## PLANNING REPORT

# Planning and Zoning Commission

## Liu Court

## 24-128PP,25-026FP

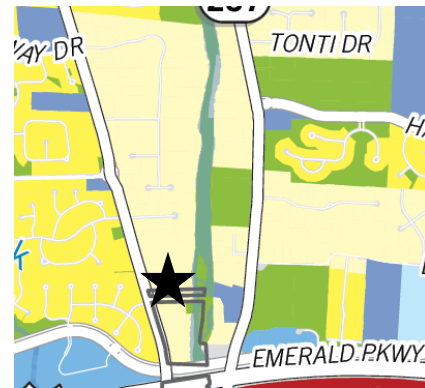
- 11) A left turn lane shall be constructed on Dublin Road to provide access to the subdivision;  
*The plat shows a left-turn lane along Dublin Road as required by Engineering.*
